SAFE YIELD ANALYSIS FOR CONESUS LAKE

Livingston County Planning Department

Schnabel Reference 21C25014.00

December 21, 2021

Figure 2.7: Schematic of Conesus Lake Outlet

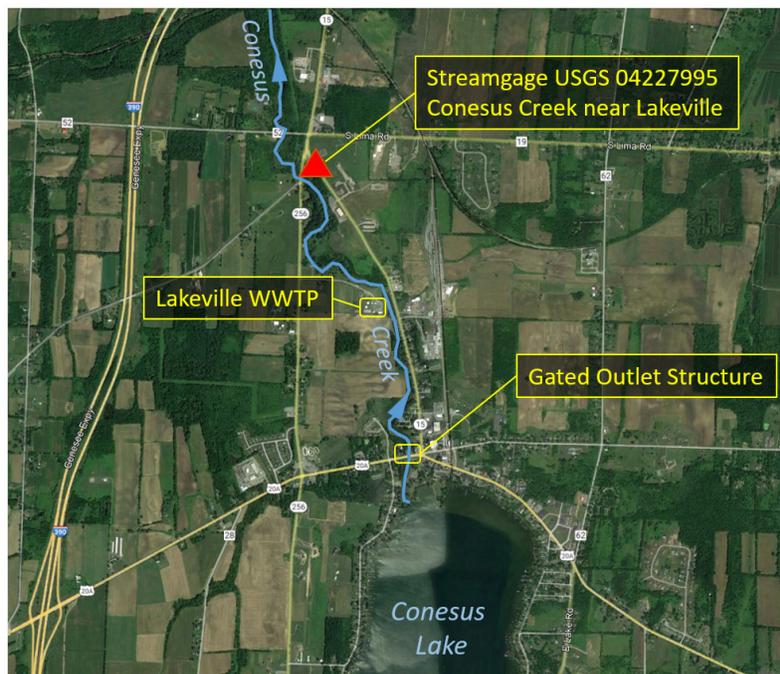
Reviewer- Conesus Lake Association				
Comment Number	Section/Page	Comment	Response	Revision to Report
CLA-1	Figure 6.2	Potential for negative impacts on lake level if water purveyors draw at permitted levels, concern is summer/fall season- current data document lake level below rule curve targets (graph of 31 yr. daily mean water level). Request additional figure of lake levels post 1989 (in addition to the 100 yr. graph).	Agree that summer/fall lake level is an important consideration. Detailed information (100 years) is presented although not averaged as requested (31 years)– refer to Figure 6.2. Impact of rule curve compliance is reflected in sensitivity run #4 and recommendation re rule curve evaluation. We note that since 2001, lake levels have been managed to adhere to the rule curve more closely.	No report revision required
CLA-2	Section 2.5 p.15	Since operationally not able to manage outflow at 10 cfs, consider either: calculate SY at 14 cfs, or commit to improvements to enable management of release at 10 cfs	NYSDEC requires a minimum 10 cfs discharge measured daily at the USGS downstream gage for water quality and habitat protection. The issue of calculating the Safe Yield at 14 cfs is addressed in sensitivity analysis and recommendations	Edited for clarity, adding schematic diagram (new Figure 2-7) to clarify location of outlet dam, outfall, and USGS gage

Figure 6.2: 100-Year Simulation of Lake Level for Current Water Supply Allocation (Low Elevation Detail Showing Instances below EL 815.5)

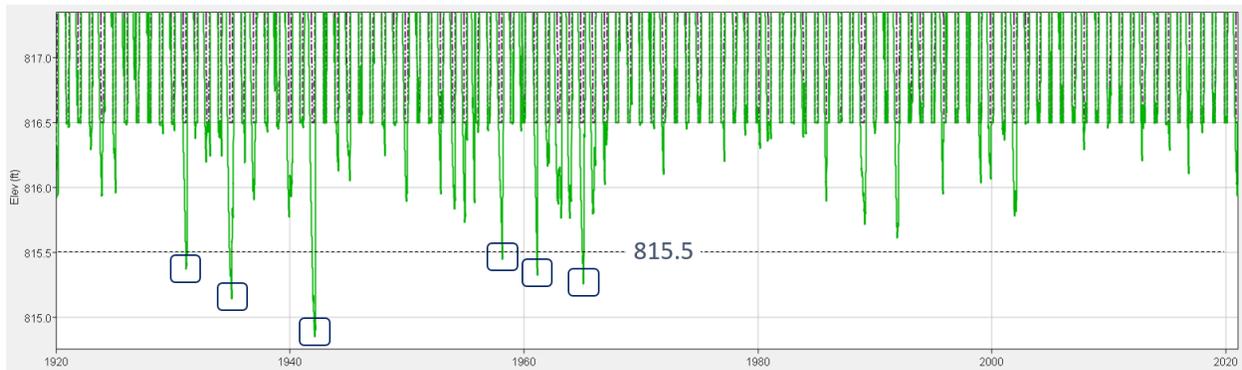
distinguishes between the water allocation and the permitted withdrawals from the existing water treatment plants.		
LCPD-15	Pg. 45, sec.6.1 and Fig. 6.2	Add text regarding the need to pump water over the outlet structure when lake level is below 815.5.	Comment noted	Edited
LCPD-16	Pg. 47	In the last paragraph, revise the second sentence from "At the current permitted water supply allocation ..." to "At the current NYSDEC allocation for the Village of Avon and Village of Geneseo water supplies ...". This distinguishes between the water allocation and the permitted withdrawals from the existing Avon and Geneseo water treatment plants.	Comment noted	Edited
